**2218KINNY - Addendum No. 2  
To Plans, Contract Documents and Specifications**

**McKinney National Airport  
Miscellaneous Erosion Repairs  
TxDOT CSJ No. 2218KINNY**

GC-101

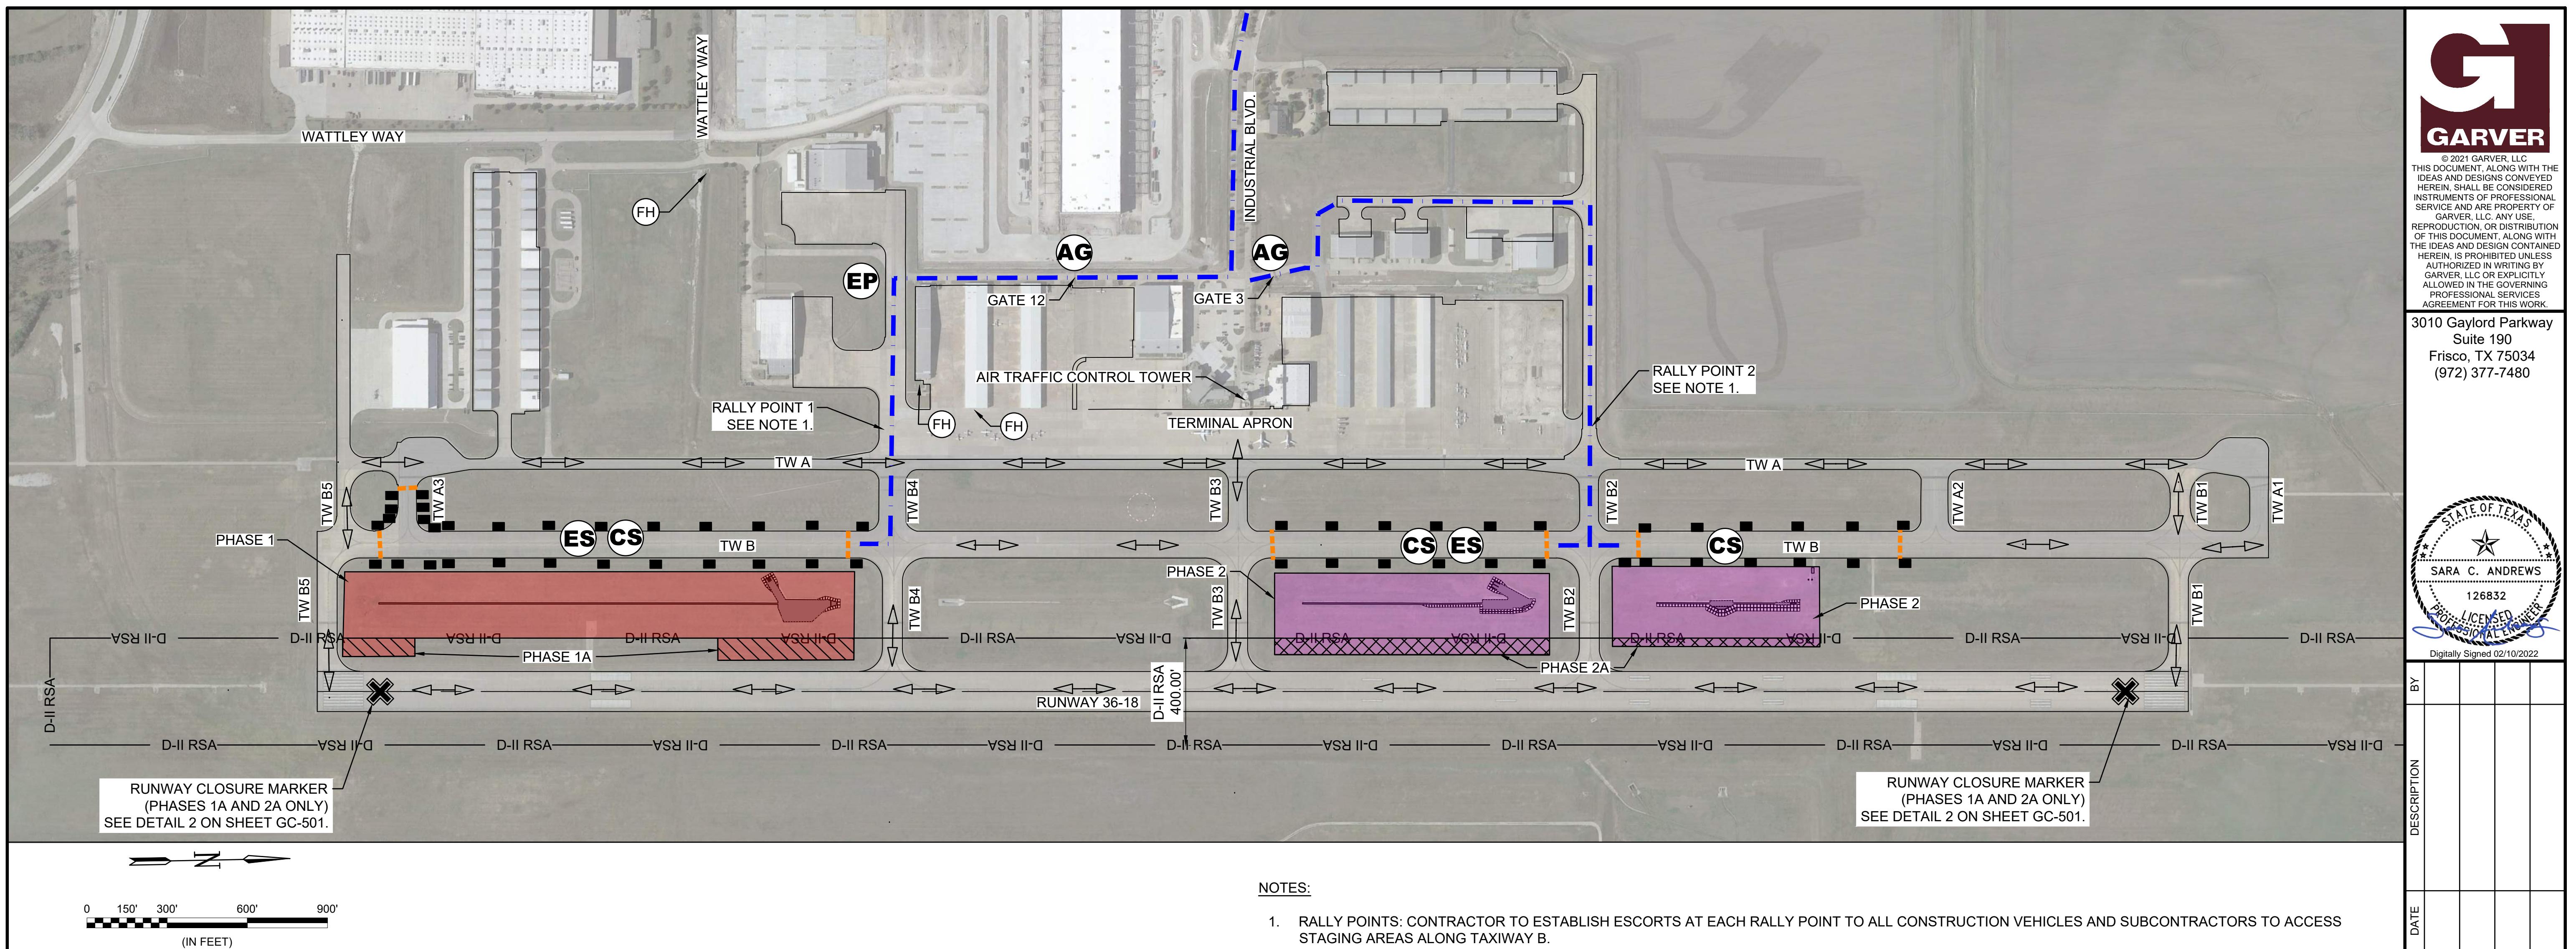
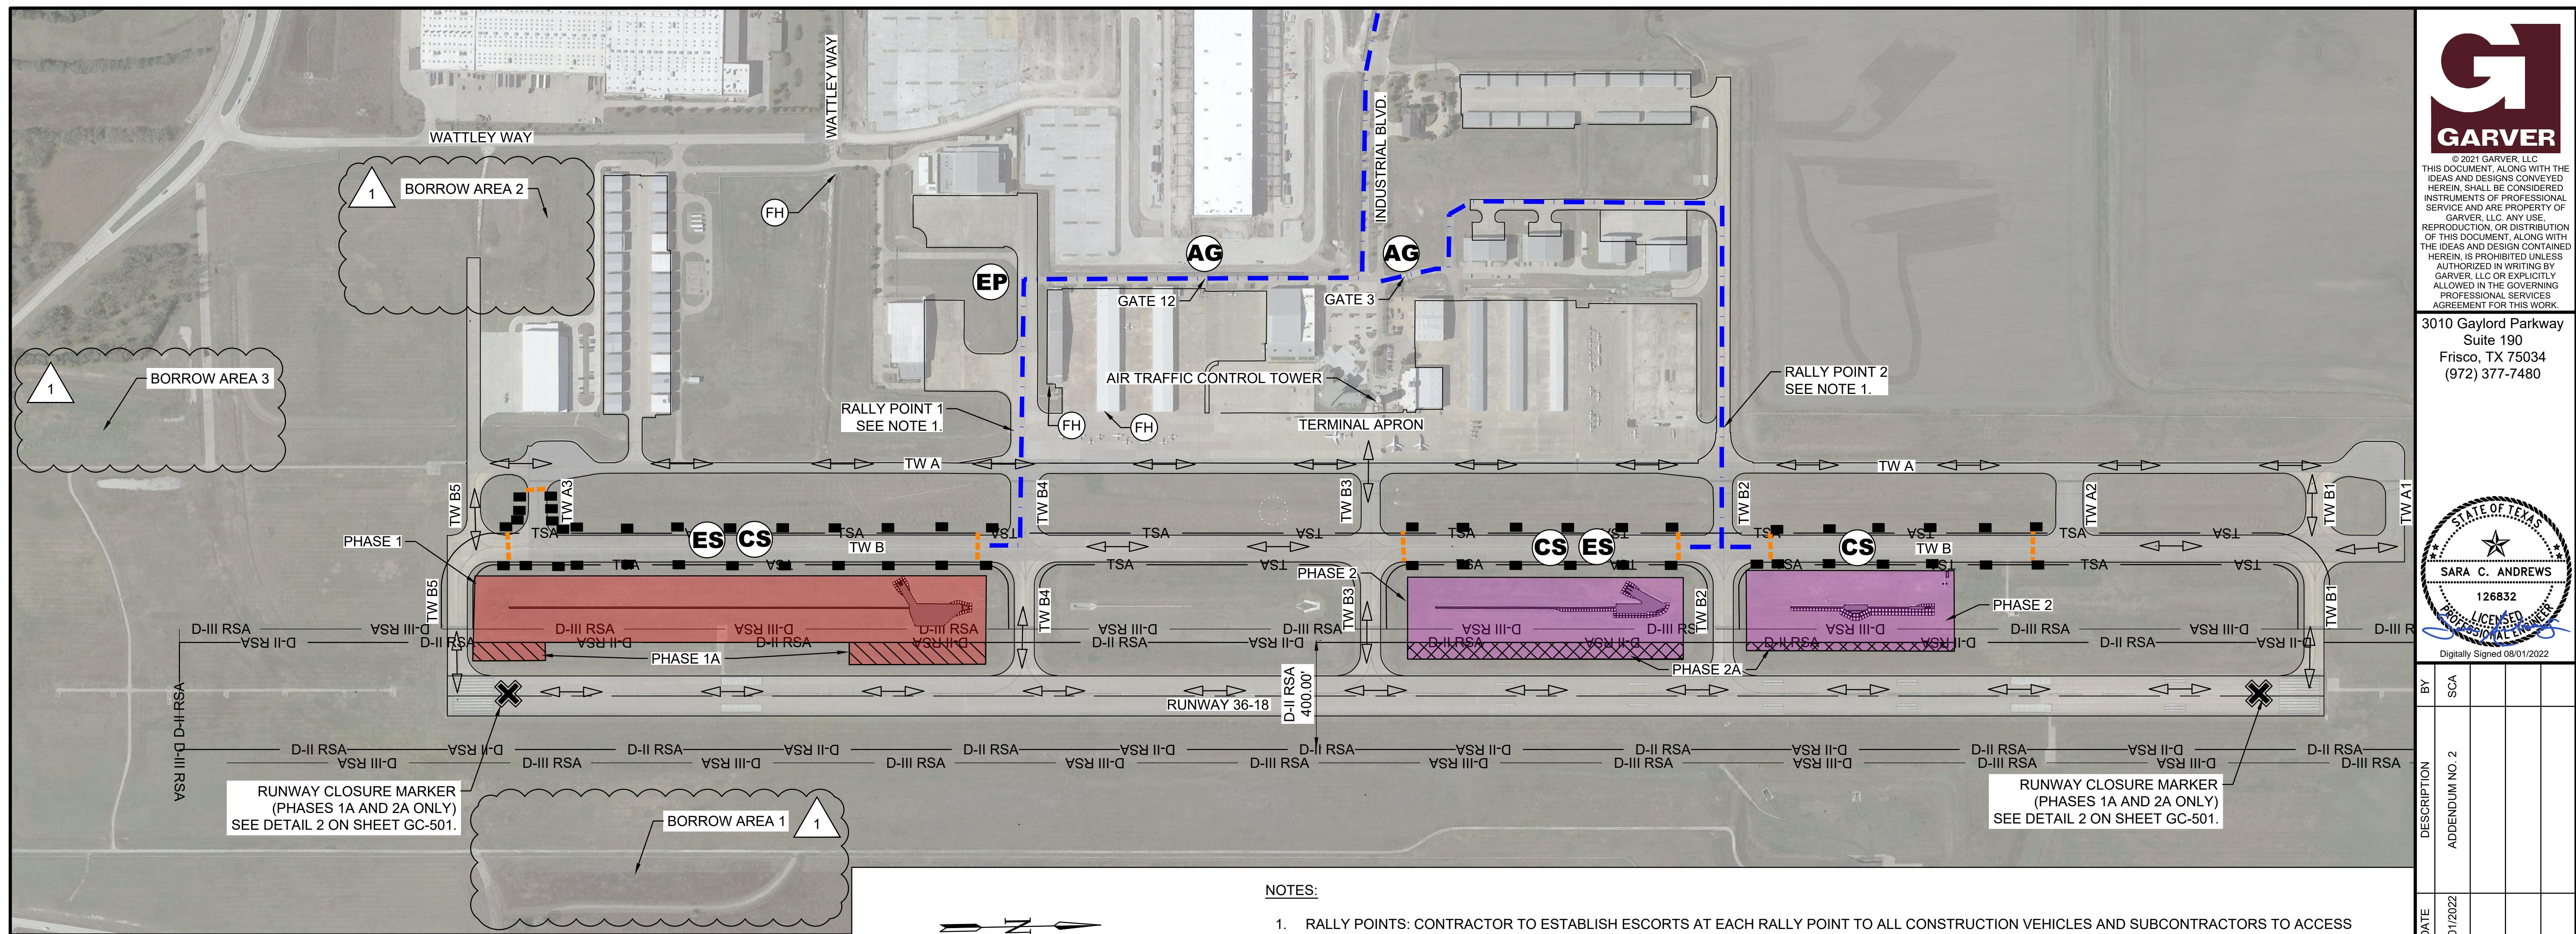
Sheet GC-101 – Revision to show the Borrow areas on the project site.

- v) *Addendum No. 2 clarifies the material properties of borrow fill and directs contractor to the plans for borrow areas.*
  - vi) *Borrow areas are shown on plan sheet GC-101 within Addendum No. 2*

- b) Is there fill available on-site?
  - i) Three (3) acceptable material sources have been identified in the plans on sheet GC-101. Before the contractor uses any fill, they must obtain a proctor on the material to ensure material properties meet P-152-5.3.

*The material used for the common fill must be tested to confirm that they meet the criteria specified as Type C fill in accordance with TxDOT Standard Specification Item 132, Type C, common fill soil. Type C soil shall be soil with the following properties: cohesion of zero, a long-term friction angle of 30 degrees, and a unit weight of 120pcf, maximum of 5% passing the #200 sieve, 0% passing the 3" sieve, Plasticity Index (PI) less than 60, and standard compaction of 95% per ASTM 1557. Fill should be placed in lifts and moisture/density controlled. Acceptable material sources have been identified in the plans on sheet GC-101.*
